2CAN091201

SUBJECT: Response to the Request for Additional Information Regarding
Request for Relief ANO2-ISI-008
Arkansas Nuclear One, Unit 2
Docket No. 50-368
License No. NPF-6

**Response to
Request for Additional Information
Request for Relief ANO2-ISI-008**

Revised Figure 5

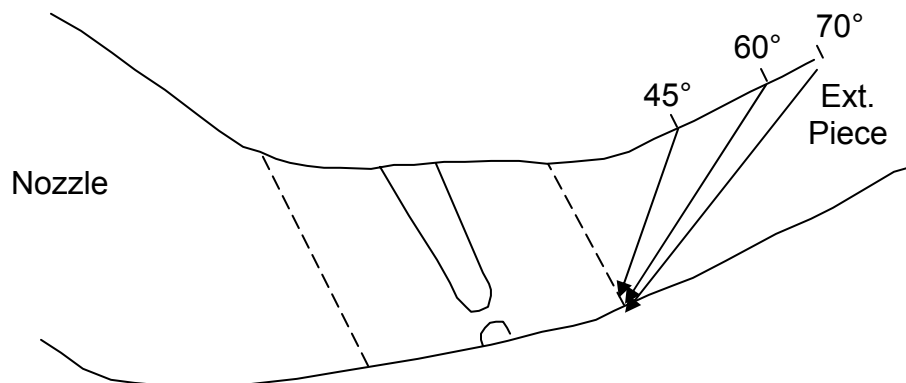
2. **For the Nozzle-to-Extension Pipe Welds contained in Table 1 for Components ID# 03-005, 03-006, and 03-007, the basis for the limitations for examination were omitted in both Table 1 and associated Figures 5, 6, and 7. Provide the descriptions of the limitations that prevented the scanning of 100 percent of the volume of the welds for the subject components.**

During the development of the response to this request it was determined that Request for Relief ANO2-ISI-008 Figures 5, 6, and 7 were incorrect. They were actually a copy of earlier figures in the same request. The correct figures are shown below and are typical of the examination scans performed in the 2003 time frame.

The limitation is due to the configuration on the nozzle side of the component. These examinations were performed in 2003. During that time, the vessel weld ultrasonic examination procedure did not specifically require scanning down a nozzle taper in a best effort attempt to enhance coverage; therefore, scanning was only credited from a single side, e.g., 50%.

The Figures 5, 6 and 7 contained in the Request for Relief ANO2-ISI-008 are typical of the examination scans performed in the 2006 inspection and depict scans down the nozzle taper. Those scans down the nozzle taper were not performed in 2003 on components 03-005, 03-006 and 03-007.

Scan Plan and Coverage for ISI Component 03-005
